1999 SEMINAR INFORMATION
"TECH ON TIME FOR '99"
INDEX
FORD & Chrysler

1999 SEMINAR INFORMATION

"TECH ON TIME FOR '99"

In this third manual on "TECH ON TIME FOR '99" seminar, we begin with FORD'S new 4R100. A look at the E4OD, AX4S/AX4N, AODE/4R70W and the 4R44E transmissions are just a portion of the information provided in this section of the seminar. Updates and part changes, problems and fixes for FORD transmissions fills this manual with valuable information. This manual concludes with information on Chrysler units including a look at the new 45RFE.

1992-1995 AODE/4R70W CHECKBALL LOCATIONS

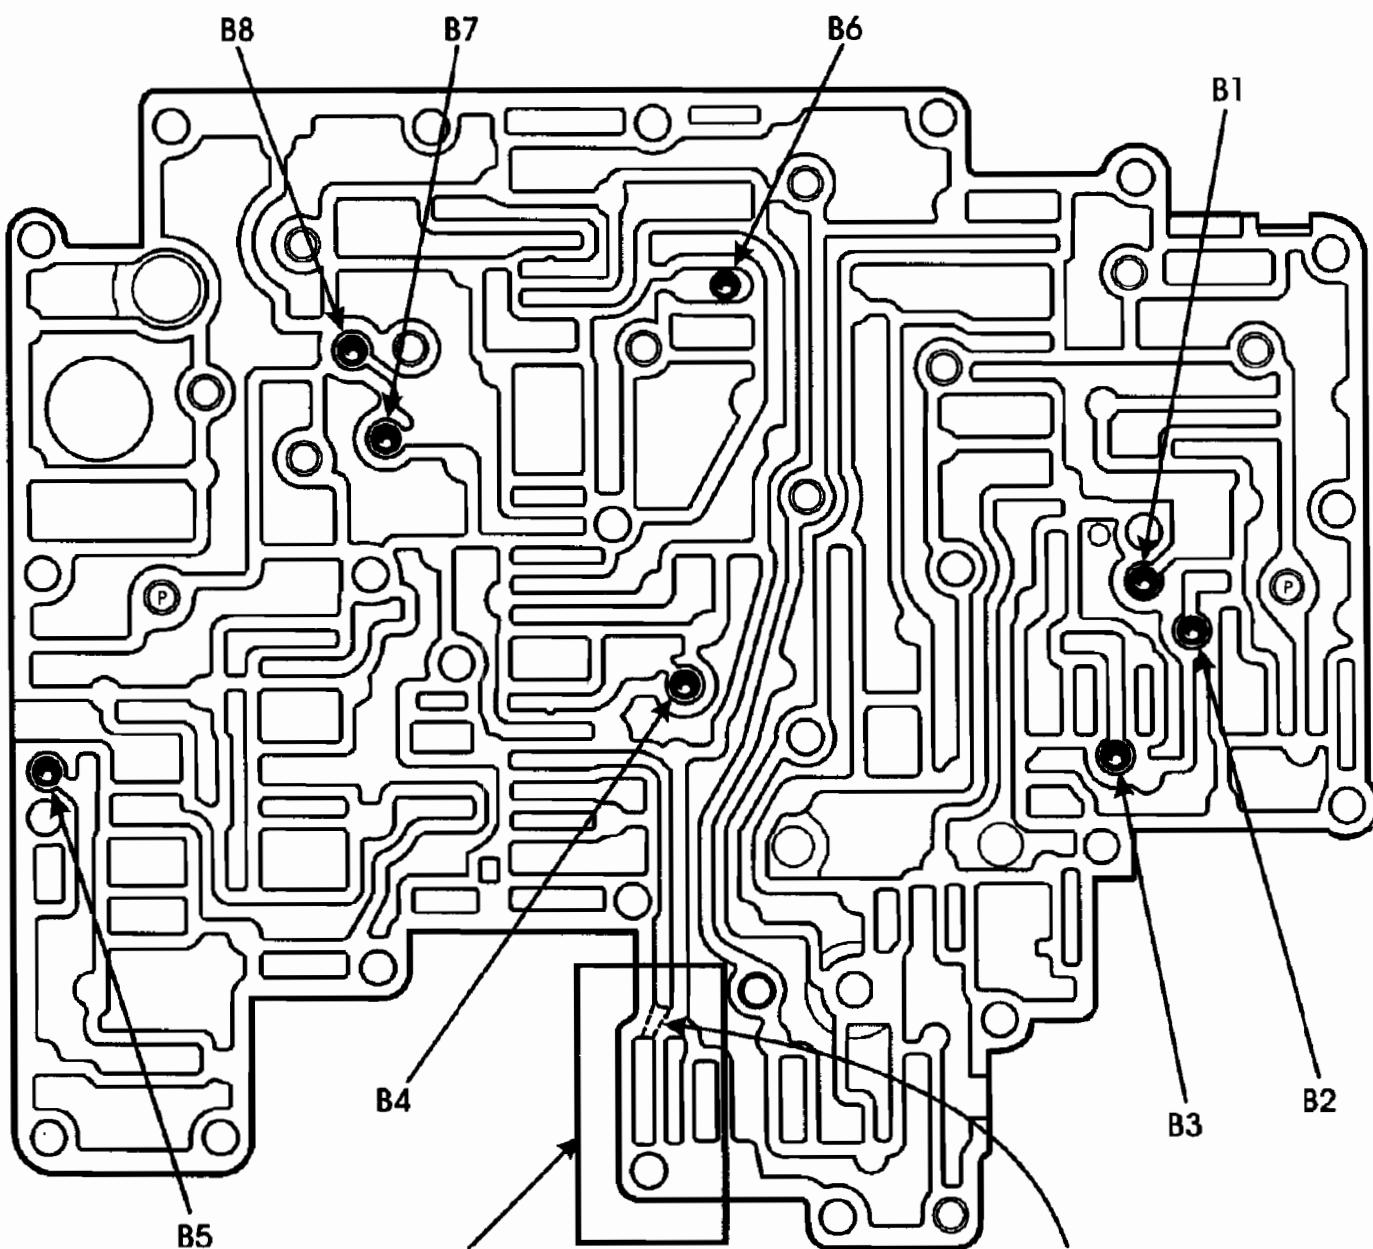
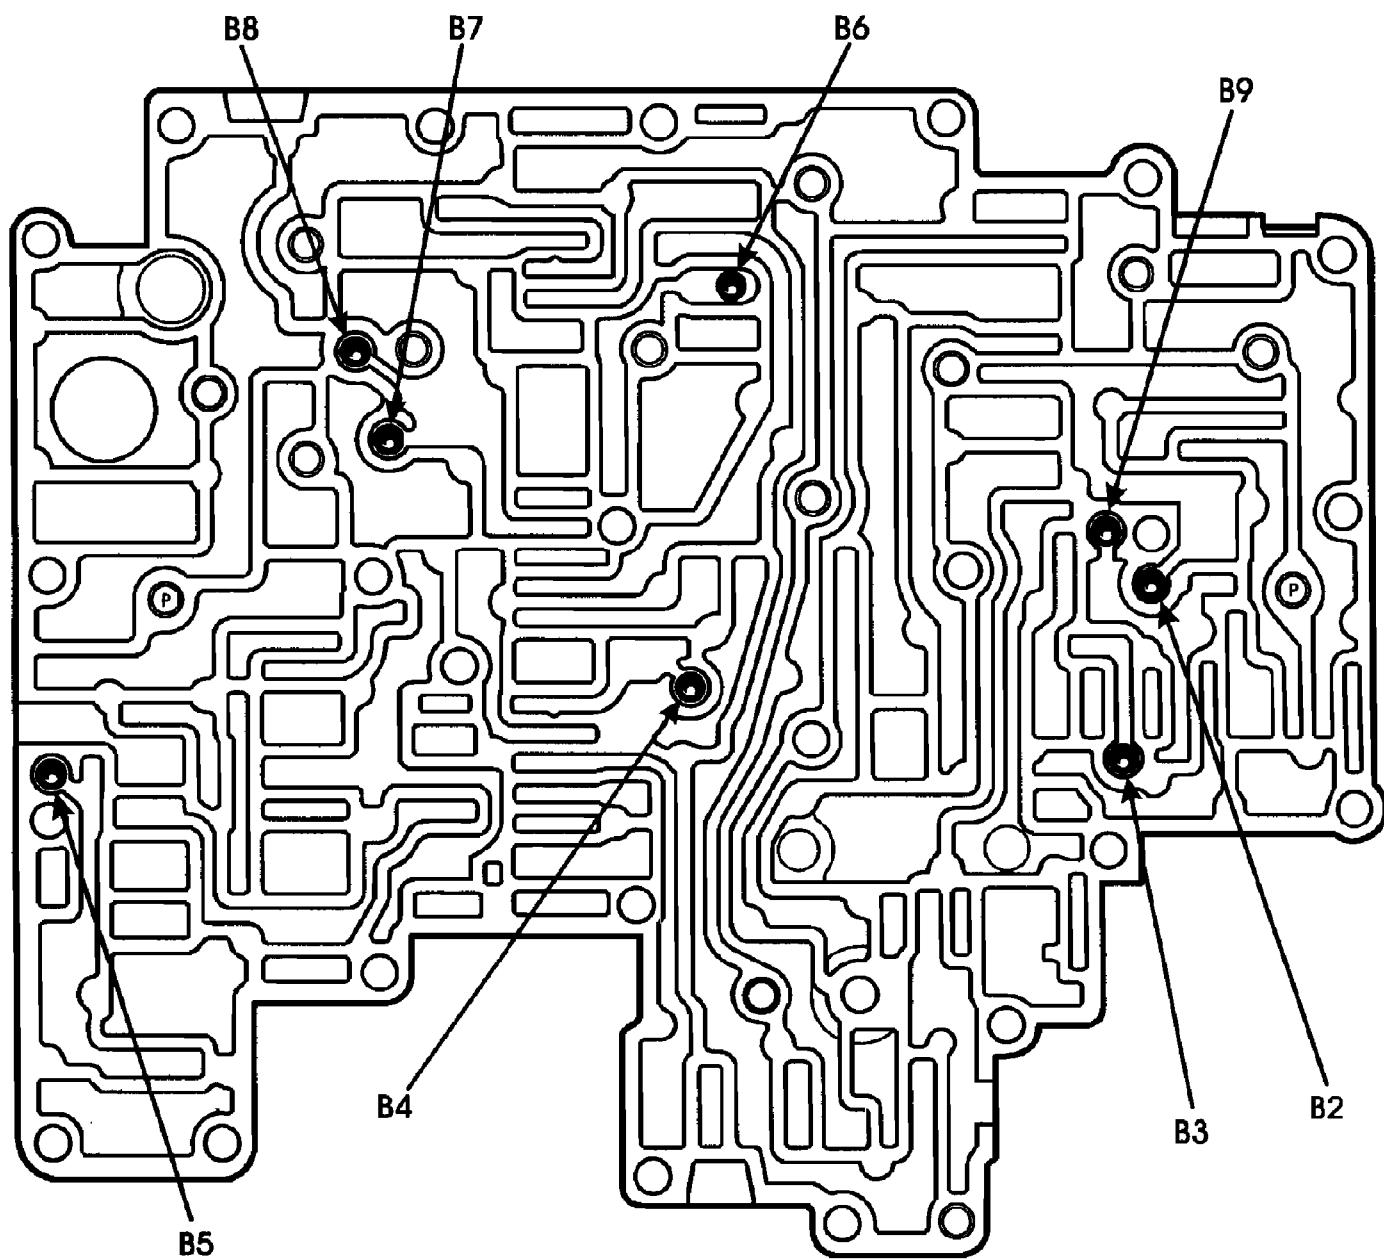
CHANGE: Beginning in the 1996 model year Ford Motor Company changed the checkball locations in the main valve body on AODE/4R70W transmissions. The Number 1 checkball in the 1992-1995 models was eliminated, the location was moved and the ball was re-numbered as the Number 9 checkball. Refer to Figures 1, 2 and 3.

Figure 2

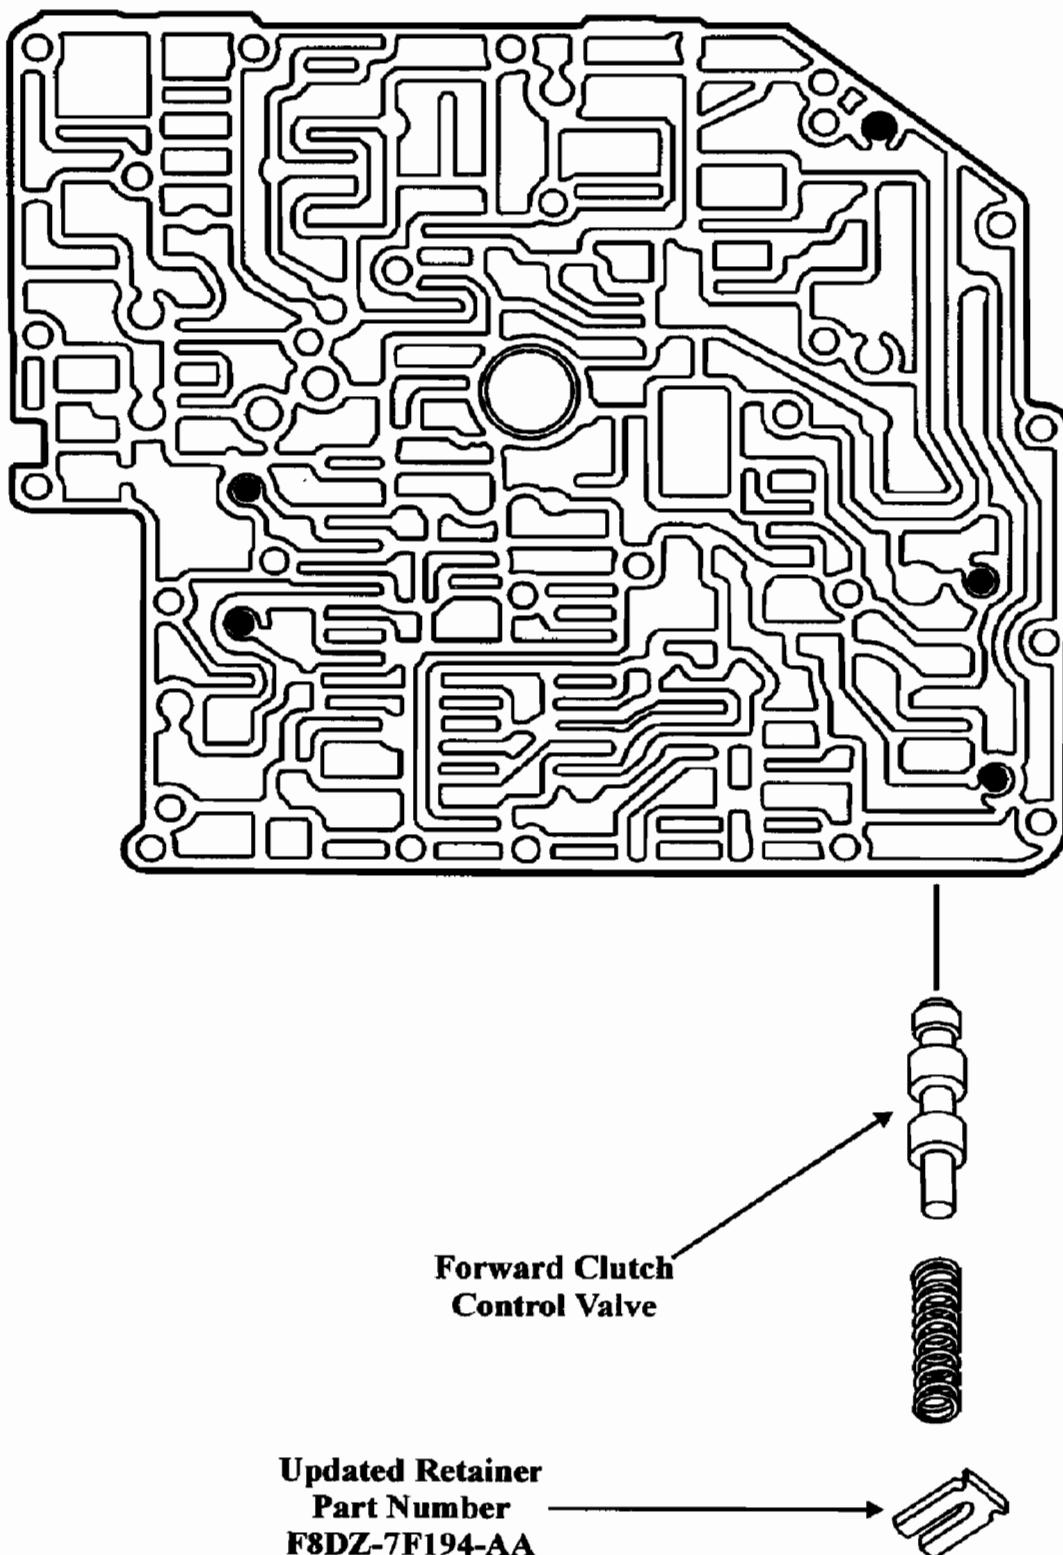
After all electrical systems have been checked and verified for proper operation, remove the Valve Body, check the Forward Clutch Control Valve for sticking, and for debris that may be obstructing the valve movement. See Figure 2. **Note:** The Forward Clutch Control Valve retainer may be bent or broken, which can cause the valve to stick. Replace if necessary. An updated retainer can be purchased from Ford, under part number

Figure 1

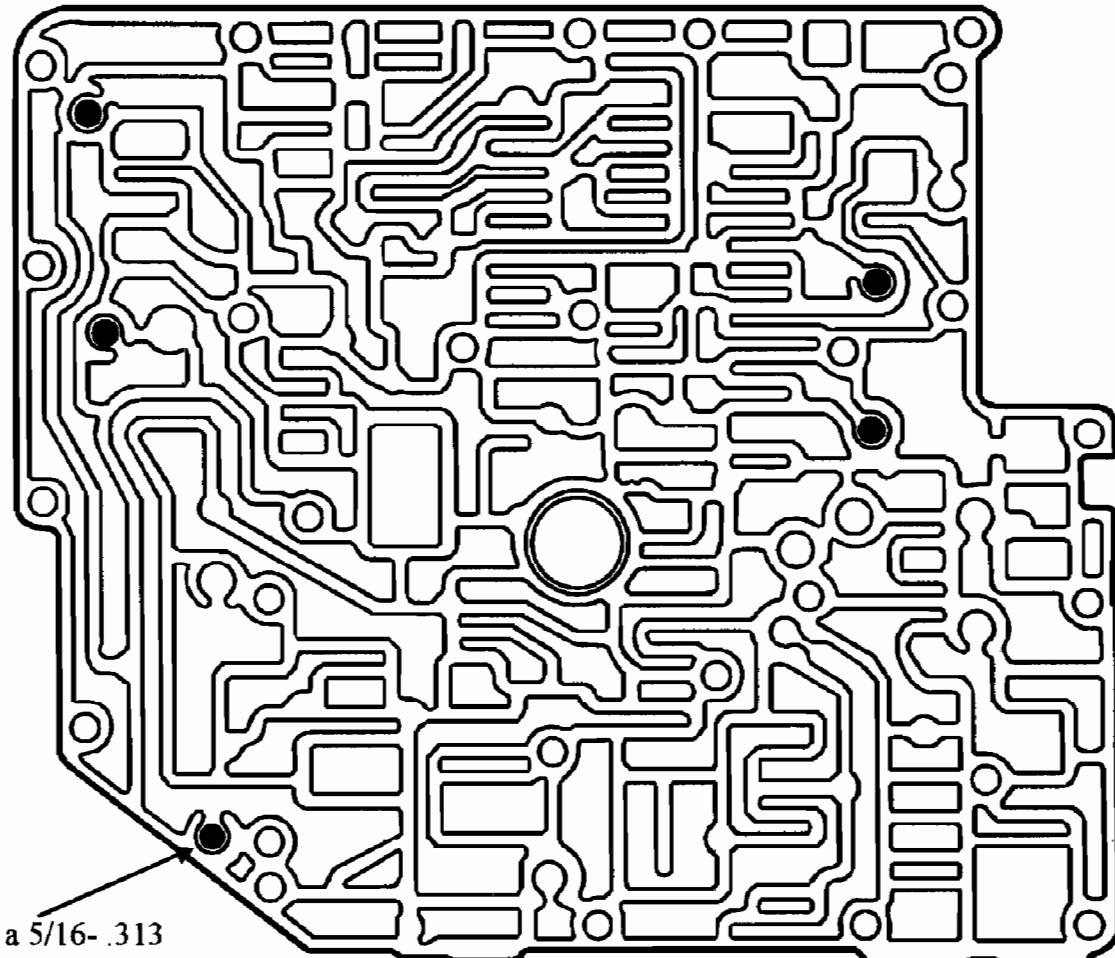
CORRECTION: To correct this condition, install a 5/16 - .313 inches checkball at the B1 location. See Figure 1.

Figure 1

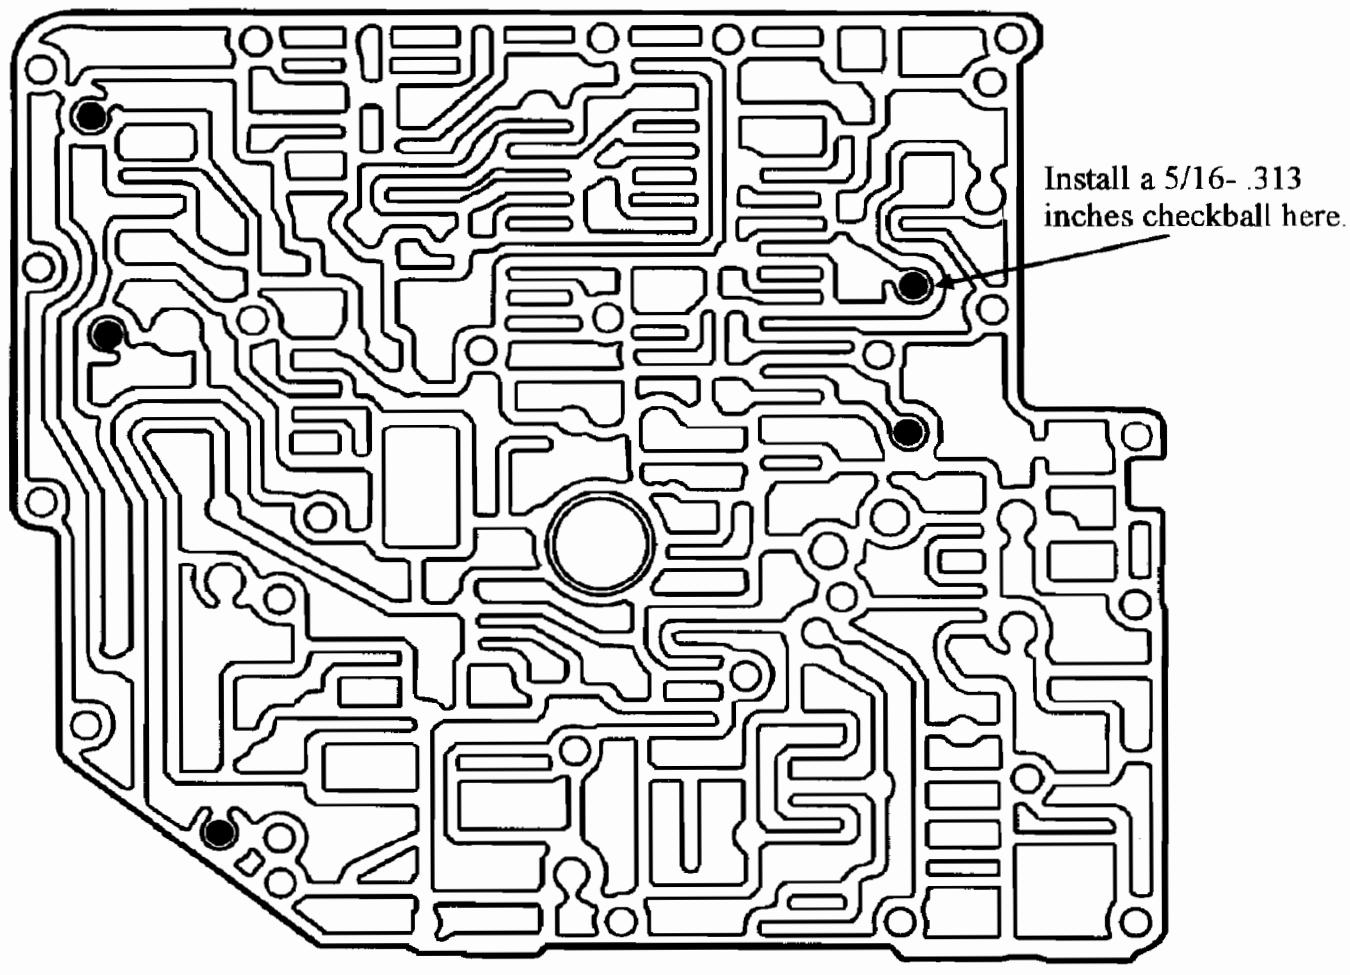
CORRECTION: To correct this condition, install a 5/16 - .313 inches checkball at the B10 location. See Figure 1.

Figure 1

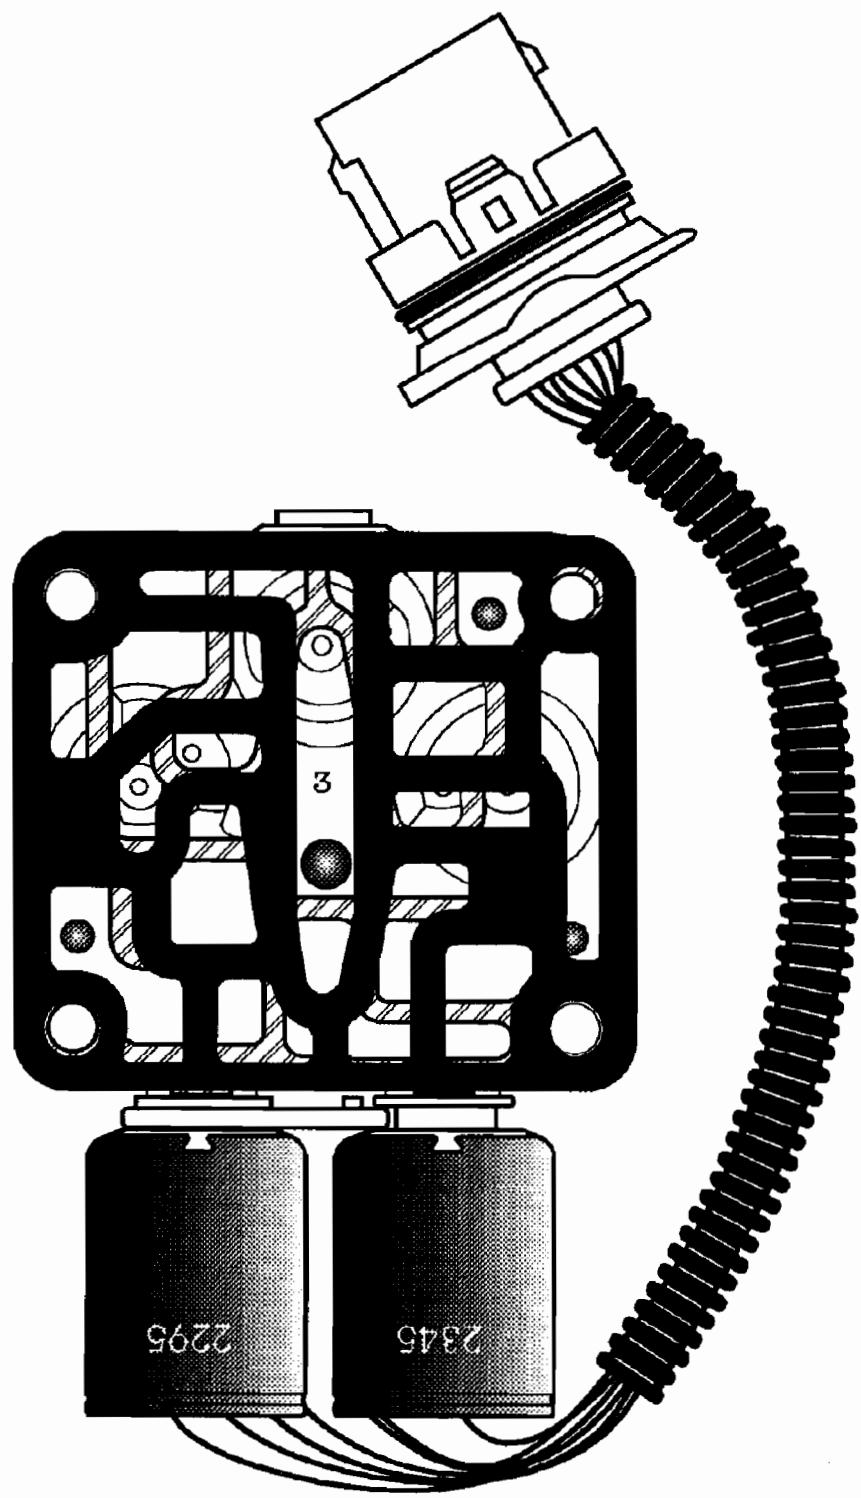
CORRECTION: The solenoid body has two alignment dowel pins in opposite corners (See Figure 1). This allows the possibility of the solenoid filter gasket to be installed in two different positions. Figure 2 shows the **INCORRECT** positioning of the filter gasket. Figure 3 shows the **CORRECT** filter gasket position.
